Introduction

I found these books to be very helpful for specific problems and troubles as found and documented by the TV manufacturers themselves during the 50's. I decided they would be helpful to others in the hobby of fixing up and obsessing over old TV's like myself. Please let me know if you see any issues with the scans or need clarification on something that is not clear/visible in a scan.

VOLUME 4

Fig. 1 — Philharmonic

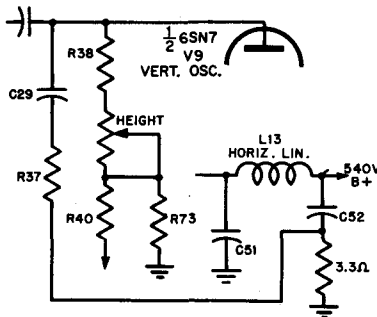
1. Place a 3.3-ohm resistor in series with C52 (.05 μ f) to ground. This capacitor, shown in the figure,

is connected to one side of the linearity coil.

Fig. 2 — Philharmonic

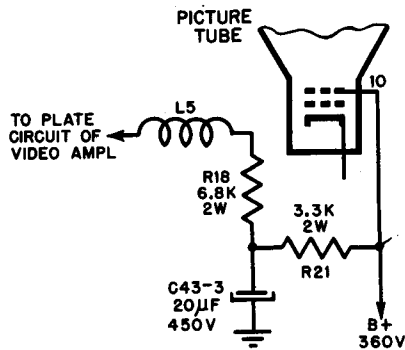
If the set is going to be operated under conditions of low line voltages (less than 105 volts), make the following changes:

1. Remove C58, .02- μ f, 1,000-volt capacitor connected between pin 10 of the picture tube and ground.

2. Remove R76, 10-k resistor connected to pin 10 of the picture tube.

Fig. 3 - Pilot

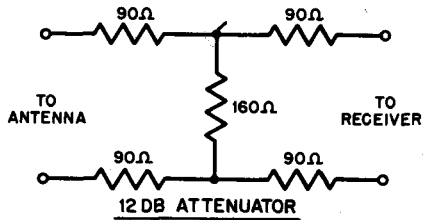
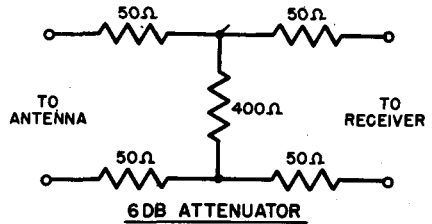
In strong-signal areas, excessive input at the antenna terminals will produce picture smear and picture jitter. This is due to cross-modulation effects in the r-f amplifier which

may operate as a detector on the nonlinear portion of its curve near cut-off. An attenuation network at the antenna terminals will remedy this condition. A 6-db and a 12-db attenuator network are shown in the figure.

Fig. 5 - RCA Victor

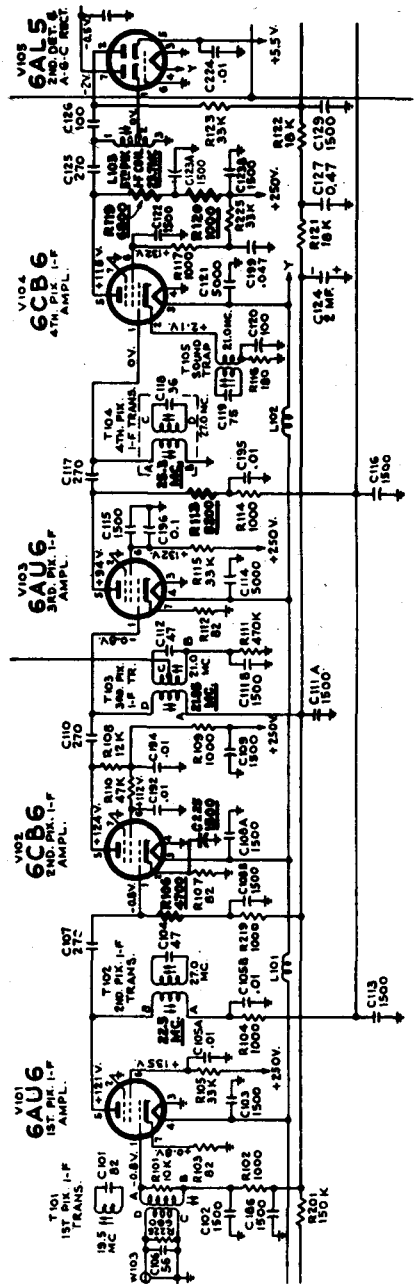
In those fringe areas where additional sound gain is desirable, the

following suggestion will effect up to a 4 to 1 increase in sound gain. See the figure for a partial schematic diagram showing the changes for model 7T103.

1. Change the second picture i-f grid resistor (*R106* in 17- and 19-inch models, *R107* in 14-inch models) from 8,200 to 4,700 ohms.

2. Change the third picture i-f plate-load resistor (*R113* in 17- and 19-inch models, *R115* in 14-inch models) from 1,800 to 8,200 ohms.

3. Change the fourth picture i-f plate-isolating resistor (*R120* in all models) from 6,800 to 1,000 ohms.

4. Remove the fourth picture i-f plate-load resistor and peaking coil (*R119* and *L114* in all models). In some cases, *L114* is wound on *R119*.

6. Add a 1,500- μ f ceramic capacitor across the second picture i-f cathode resistor (pin 2 of *V102* to ground). Use the shortest possible leads.

Fig. 6 - RCA Victor

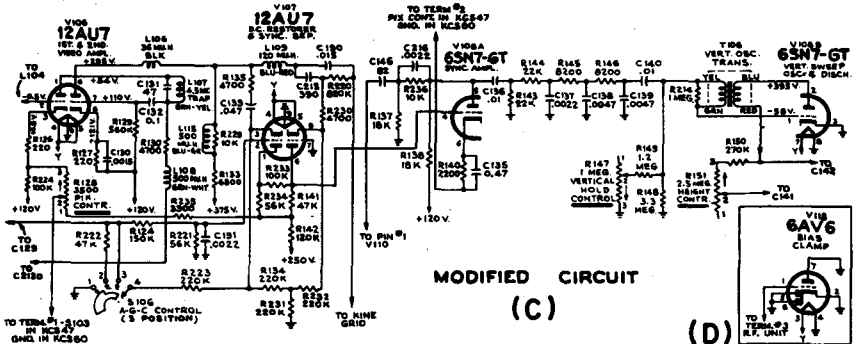
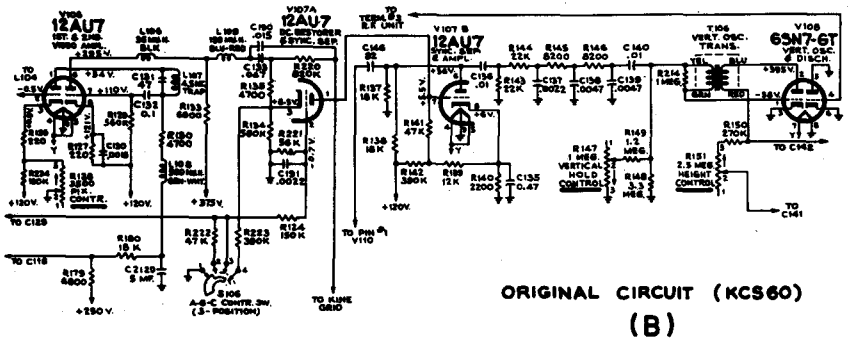
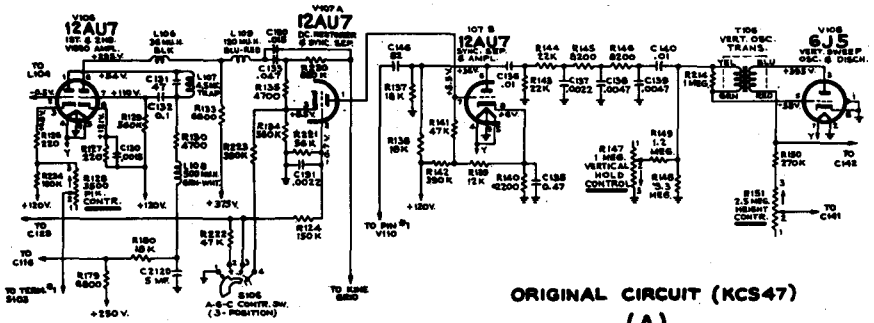
Part (A) of the figure shows the conventional 16-inch and 19-inch table model and console (chassis KCS47) sync separator, d-c restorer, sync amplifier and vertical-oscillator circuits. Part (B) of the figure shows the schematic of the same circuits of the 16-inch and 19-inch combination instruments (chassis KCS60).

Part (C) of the figure shows the modified sync, d-c restorer, and vertical-oscillator circuits, which are the same for both straight television instruments and combinations. When these modifications are made, the sync stability is increased in low-signal strength, high-noise areas.

Comparing part (A) with part (C), it will be noted that V107, which was originally used as a d-c restorer, sync separator and amplifier, is reconnected with the first half of the tube as d-c restorer and horizontal-sync separator, and with the second half connected as a vertical-sync separator. V108, which was a 6J5 type used as a vertical-sweep oscillator and discharge tube, is replaced by a 6SN7 type, half of which is used as the vertical-sweep oscillator and discharge tube, while the

remaining half is used as a sync amplifier.

tion of the 6SN7 tube V108 which was formerly used as a bias-clamp is reconnected as a sync amplifier, and it is necessary to install a separate bias-clamp tube. The connections for the additional bias-clamp are shown in part (D) of the figure. Although type 6AV6 is recommend-

Fig. 7 — RCA Victor

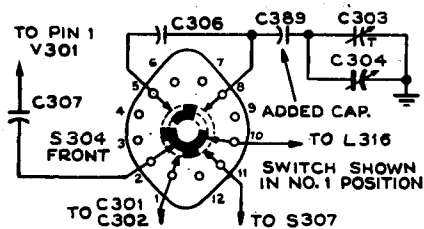
A .05- μ f capacitor, designated C389 was added between terminal 8 of function switch S304 (front) and tuning capacitor C303/C304 in radio chassis RC617A.

Early production models of the receiver will not have this capacitor in the radio chassis.

When the radio-function switch is in the TV position, the filament voltage is present on the high side of the tuning capacitor (C303/C304) due to the function switch design. Any shorting of the tuning capacitors to ground causes L314 (filament choke) to burn out. The insertion of the capacitor removes filament voltage from the tuning capacitor without affecting its operation.

Fig. 8 — RCA Victor

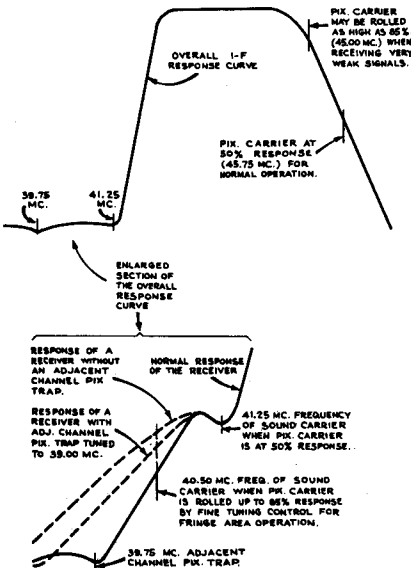
it is common practice to adjust the fine-tuning control so as to move the picture carrier up the slope to improve the signal-to-noise ratio. The actual amount that the carrier is moved depends upon the signal strength. On extremely weak signals, the picture carrier may be moved as high as 80 to 90 percent on the slope of the curve. This may represent a change of as much as 75 megacycles of all frequencies being passed through the picture i-f amplifier. Under such conditions the sound may become weak and noisy even on intercarrier receivers. The reason for this is shown in the figure.

When the picture carrier is rolled up the slope and lowered in frequency by .75 mc, the sound carrier is also lowered in frequency by .75 mc to become 40.50 mc. As can be seen by the enlarged section of the response curve, the sound carrier begins to fall into the adjacent channel picture trap with a consequent reduction of sound output. Receiver designs which do not incorporate an adjacent channel picture trap may avoid this difficulty at the expense of adjacent channel picture rejection.

It is possible to overcome the above described difficulty in many cases by a simple adjustment which can be made in the field without the aid of test equipment. When the picture carrier is rolled up the slope by .75 mc, the adjacent channel picture carrier is lowered in frequency to 39.00 mc and no longer falls into the adjacent channel picture trap. If the trap is returned to 39.00 mc, it will permit the response at 40.50 mc to rise somewhat, produce stronger sound, and will produce greater adjacent channel picture rejection un-

der the actual operating condition. If a strong signal is available on another channel and the fine tuning is adjusted to roll the picture carrier down the slope to the normal 50-percent point, the adjacent channel picture trap will appear mistuned. However, it is not likely that adjacent channel picture interference will be experienced on strong signals.

Fig. 9 — RCA Victor

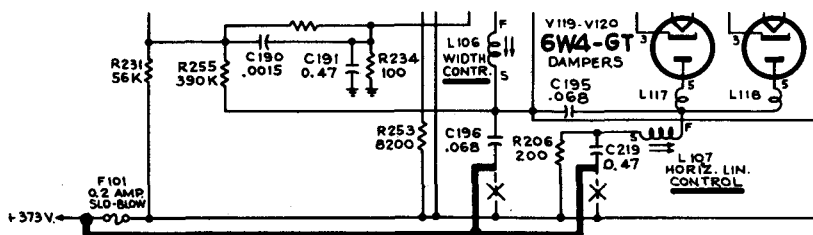
In a few 21-inch receivers, the slow-blow fuse has been known to fail due to a-c from the sweep circuit flowing through *F101*. To elim-

inate this difficulty the factory has made a wiring change. *C196* (.068 μ f) and *C219* (.047 μ f) were changed from their original connection and reconnected to the +373 volt bus side of the fuse as shown in the partial schematic diagram.

As a field-service convenience, if a slow-blow type fuse fails in an unmodified 21-inch receiver, it should be replaced by a quick-blow type (stock No. 73600). However, if an unmodified receiver is brought into the shop for service, *C196* and *C219* should be reconnected and a slow-blow fuse installed.

Fig. 10 — RCA Victor

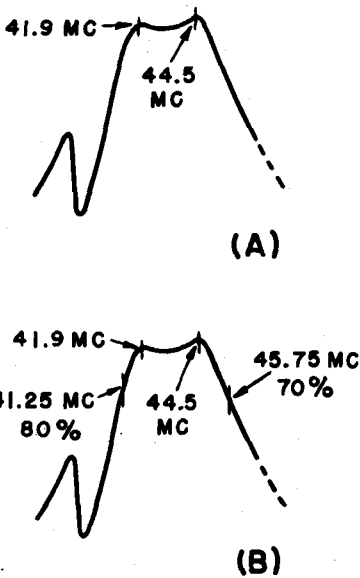
It has been found desirable to align *T1* (converter transformer) and *T104* (1st picture i-f grid transformer) to the response shown in part (B) of the figure rather than as it appears in the service data (see part A).

Fig. 11 — RCA Victor

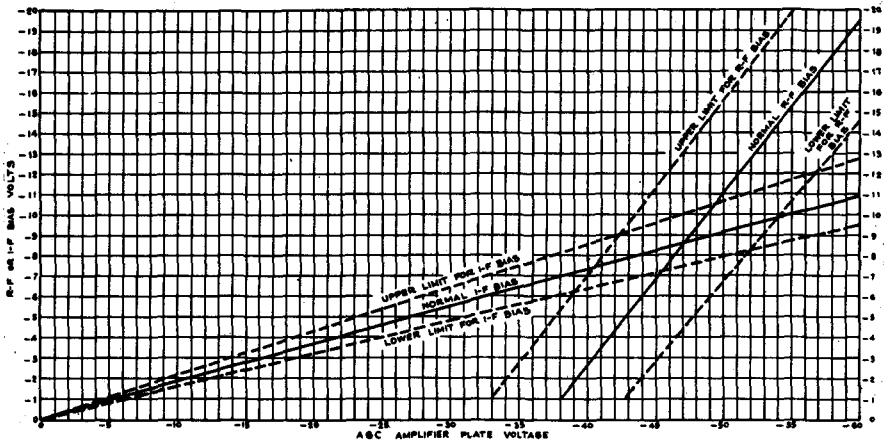
To determine whether or not the biases are of the correct ratio, tune in a signal and measure the r-f bias, the i-f bias, and the agc amplifier plate voltage with a VTVM. The signal must be steady during these measurements. Plot these points on the accompanying graph. The values should fall within the range of the dotted lines.

According to the graph, when the agc amplifier plate measures -45 volts, the i-f bias should be -8.2 volts. If the i-f bias actually measured -10 volts, it indicates that *R143* (68-k resistor in i-f agc bus) or *R145* (150-k resistor connected to plate of agc amplifier) is too low

in value and/or *R144* or *R150* (82-k and 150-k resistors connected to ground in the i-f agc bus) is too high. If, however, the i-f bias actually measured —6 volts, it indicates *R143* or *R145* is too high in value and/or *R144* or *R150* is too low. The resistors originally employed in production were 10 percent tolerance units. However, if *R143* and *R145* are at one limit of their tolerance and *R144* and *R150* are at the other limit of their tolerance, a considerable error in i-f bias is produced.

Fig. 13 — RCA Victor

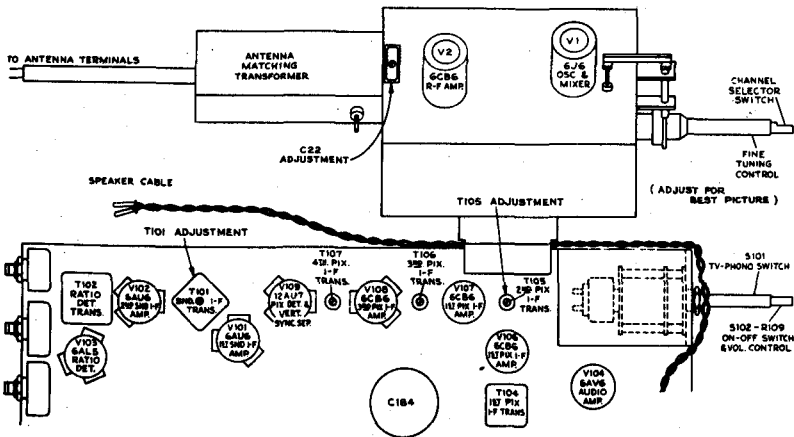
In setting the age control on these receivers, care must be taken that the receiver is generating the maximum age voltage which will be required for that particular location of the receiver. If the age control is adjusted on a weak signal, the receiver may overload, bend on sync, etc., when a stronger signal is received.

The correct age adjustment, explained in equipment service notes, is important in obtaining the best performance from the receiver. Adequate picture contrast may also be difficult to obtain if the age control is not properly adjusted, inasmuch as the age control setting determines the i-f signal voltage level appearing at the picture second detector. In medium- and strong-signal areas, this adjustment should be made on the strongest signal to avoid receiver overload. In weak-signal areas, the maximum clockwise adjustment which gives best signal-to-noise ratio (minimum snow) may be preferred.

One source of difficulty not likely to be suspected is the position of the fine-tuning control. If the age control is adjusted with the fine tuning set so that the picture carrier is low on the slope of the i-f response curve, then the receiver may overload or bend on sync when the picture carrier is moved up the slope with the fine-tuning control. The obvious cure is to set fine tuning so that the picture carrier is well up the slope (fine tuning counterclockwise on KRK8) when making final adjustment of the age control.

Fig. 14 — RCA Victor

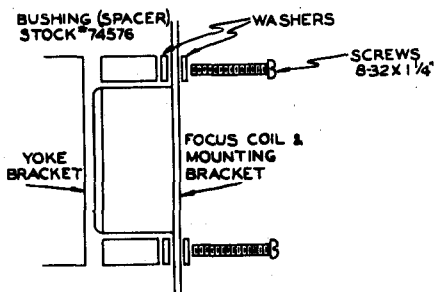
If it is impossible to remove picture-tube shadows by the prescribed method (see service notes) of adjusting the focus coil and ion-trap magnet, then make the following test:

1. Remove the two focus coil mounting screws (8-32 x $\frac{3}{8}$ ") and reverse the focus coil. Temporarily replace it in a position adjacent to the deflection yoke.

If the above test indicates that the focus coil in a reversed position is the desired position, then the mounting modification shown in the figure is recommended. The materials required for the focus coil mounting modification are given in the figure.

Fig. 16 - RCA Victor

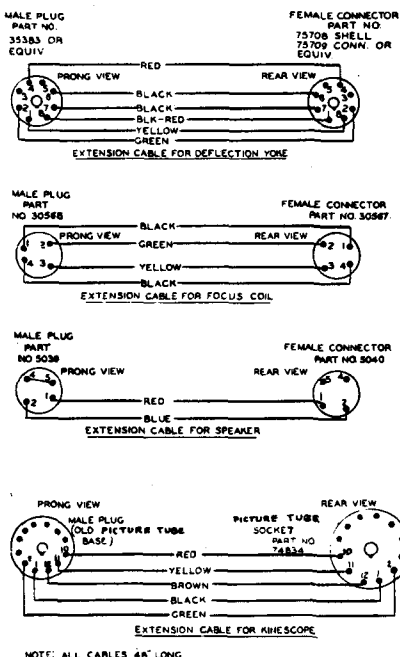
When the chassis is removed from the cabinet for service, it will be necessary to unplug the yoke and focus coil. With either of these two components out of the circuit, the receiver cannot be operated because of the +B disconnect incorporated in each plug.

The figure describes how these extension cables can be made, also stock numbers of plugs and connectors used.

Fig. 18 — RCA Victor

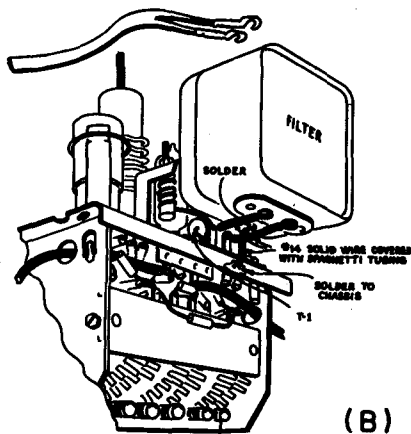
Part (A) of the figure shows the method of attaching the antenna input connectors to the filter so that

it can be plugged directly into the antenna matching units employed with KRK5, KRK7, and KRK8 r-f tuners.

Part (B) of the figure shows the method of mounting the filter on receivers employing KRK2 r-f units.

Fig. 19 — RCA Victor

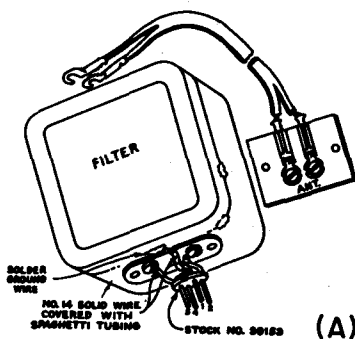
The frequency of the r-f tuner oscillator is a function of the circuit inductance and capacitance, and since the steps of inductance are fairly well fixed on channels 7 to 12, inclusive, the only sizeable variables that are available are the capacitance and the channel-13 inductance.

2. Tune for correct channel 13 oscillator frequency by using the readily available adjustments for the purpose (a capacitance trimmer on the KRK8 and an inductance slug on the KRK5).

4. If the noted frequency is higher than it should be, the channel-13 capacitance should be increased and the channel-13 inductance should be decreased. Go back to channel 13 and make the necessary changes to give both the correct frequency and an approximation of tracking correction. See the chart.

Fig. 20 — RCA Victor

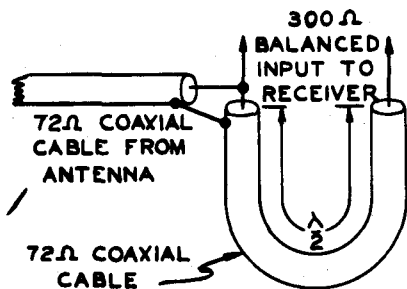
In some locations it may be necessary to use 72-ohm coax transmission line between antenna and receiver because of reflection or interference pick-up. Later receivers are provided with a 72-ohm coax input in addition to the usual 300-ohm input. Early receivers employing the above series r-f tuner units are provided only with 300-ohm balanced input. To connect the coax to these early receivers, construct a network as shown in the figure. The matching section should be one electrical half wavelength long for the picture carrier of the weakest signal received.

Fig. 23 — RCA Victor

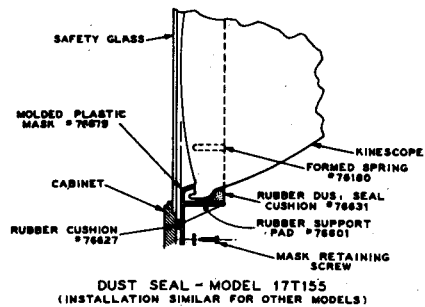
1. Apply cement (see note below) around entire periphery of both the picture tube and the mask surfaces which are in contact with the dust seal. Caution: Do not apply cement to the high-voltage clip. The spring-mounting clips should be pushed securely in place so that they do not protrude beyond the mask flange.

Fig. 24 — RCA Victor

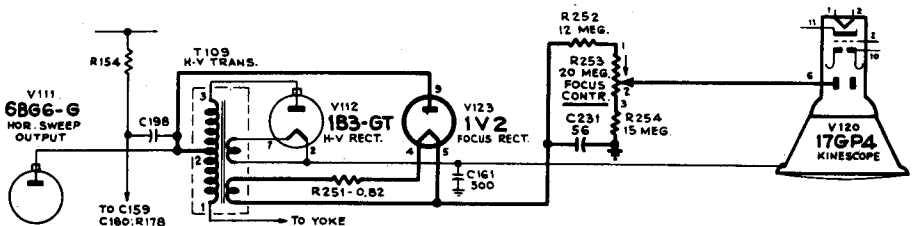
Since the focus magnet is dispensed with on the 17GP4, a new centering magnet is provided to center the picture on the screen. This magnet assembly is in the form of two wire rings mounted on a non-magnetic form which is placed around the neck of the picture tube, and at a distance of about three-eighths of an inch in back of the deflection yoke. When the magnets are rotated on the tube so that the gaps in the rings are together, then maximum picture shifting effect is produced. When the rings are rotated so that their gaps are 180 degrees apart, then little or no shifting of the picture is obtained. To shift the picture, rotate one of the magnets with respect to the other. To move the picture in a desired direction, rotate the entire centering mag-

net assembly around the neck of the picture tube. Repeat these two adjustments until the picture is properly centered and no corner shadows are obtained.

Fig. 26 — Sears Roebuck

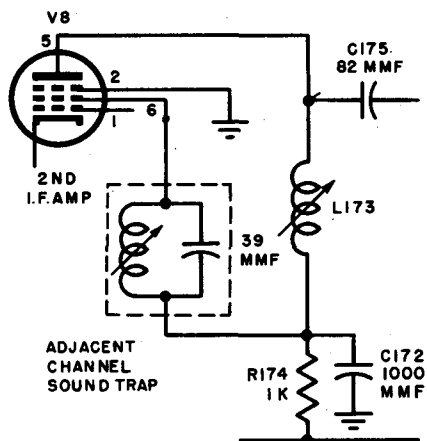
4. Disconnect the second intermediate-frequency coil *L173* from pin 6 of tube *V8* (6AU6).

5. Connect one terminal of the trap coil directly to pin 6 of tube *V8* (6AU6).

Fig. 27 — Sears Roebuck

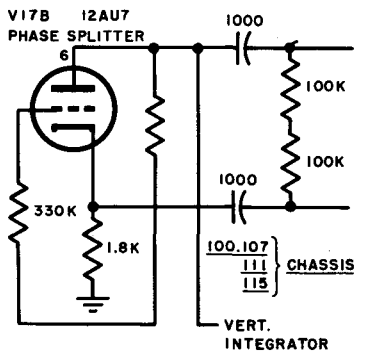
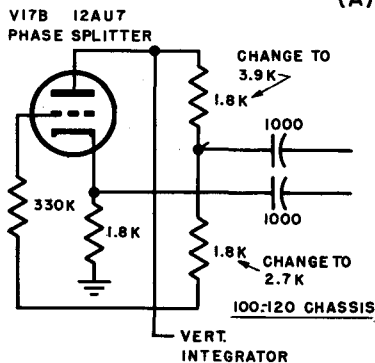
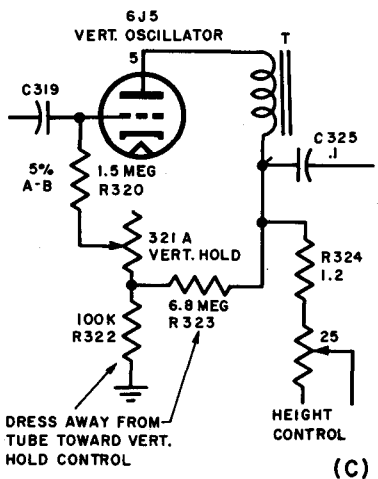
The first circuit (part A) applies to the 100.107, -.111 and -.115 chassis numbers. This circuit was changed in the 100.120 chassis (part B) for better vertical and horizontal stability and improved noise immunity. The arrangement can be incorporated in any of the early sets if complaints are received.

For further improvement in this circuit and to minimize vertical drift, the following changes may be made in low-signal areas. Change the 1.8-k resistor R351, closest to the plate of the phase splitter, to 3.9 k, and the lower 1.8-k resistor R246 to

Fig. 28 — Sears Roebuck

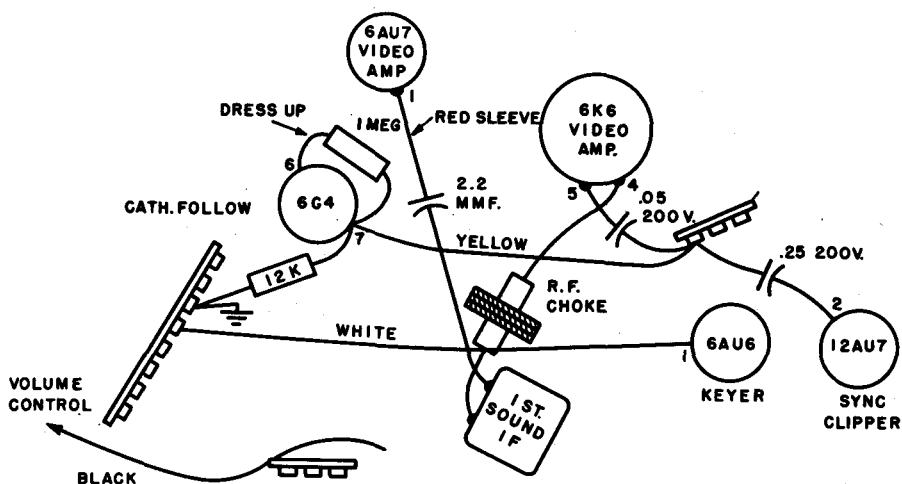
This buzz can be eliminated through careful lead dress of the offending parts. In particular, the yellow lead to the cathode of the keyer tube and the white wire to the grid of the same tube. Both leads are

heavy radiators of radio frequency. By locating a radio-frequency choke between these paralleled leads and the 2.2- μ f red-sleeved capacitor, the buzz is reduced to a minimum.

Fig. 29 — Sears Roebuck

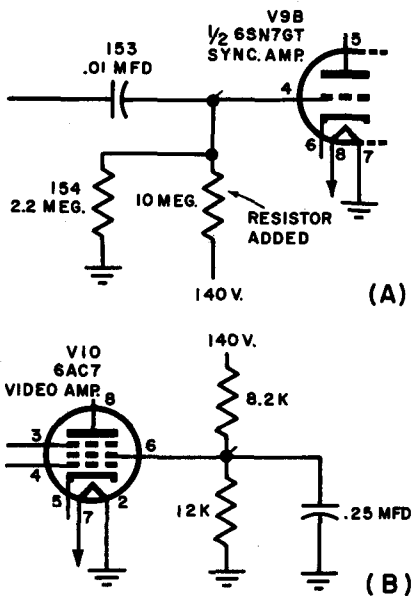
To improve the horizontal stability and eliminate all trace of jitter, a 1.3-ohm resistor is placed in series with the filament of the 6AL5 horizontal phase detector to lower the filament voltage and eliminate the effect of variance in tubes. This change has already been included in later production.

Fig. 30 - Sears Roebuck

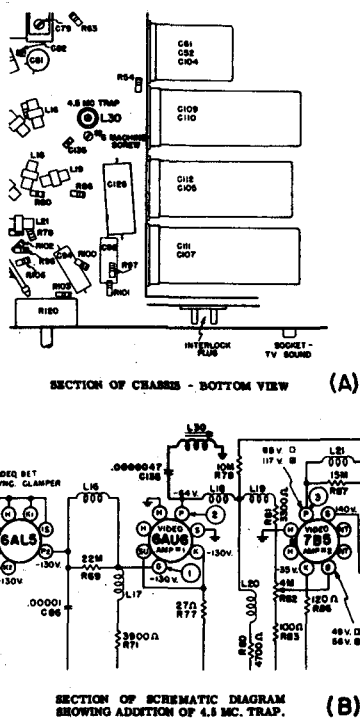
Later production of the above chassis incorporates a 4.5-mc trap off the plate of the first video-amplifier tube 6AU6. This is necessary to

Fig. 32 — Sears Roebuck

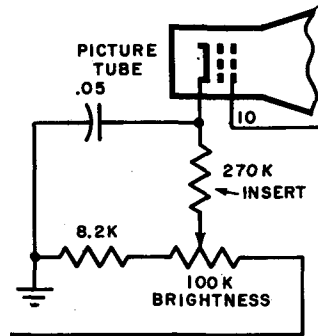
To correct this condition, remove the yellow wire from pin 11, cathode, of the picture tube and remove the .05- μ f capacitor, *C28*, from the center arm of the brightness control. Attach a 270,000-ohm, 1-watt resistor to the center arm of the brightness control. Attach the other end of the resistor to the yellow wire from pin 11 and the .05- μ f capacitor. It will be noted that to obtain good

Fig. 33 — Sears Roebuck

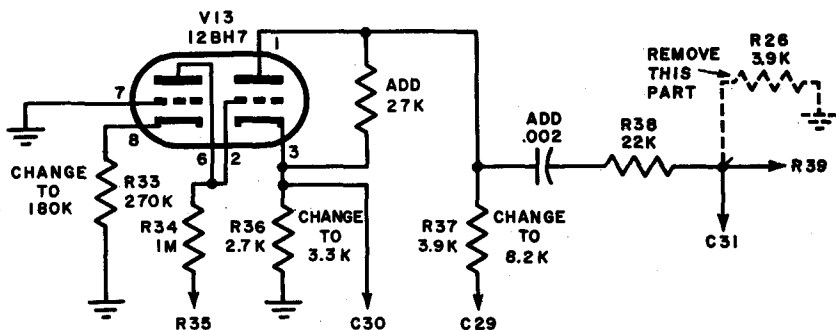
In fringe areas where the above chassis is more critical vertically and more susceptible to noise pulses, it is possible by making a few minor component changes to improve the noise immunity and vertical stability. The changes should be made as follows (see the figure):
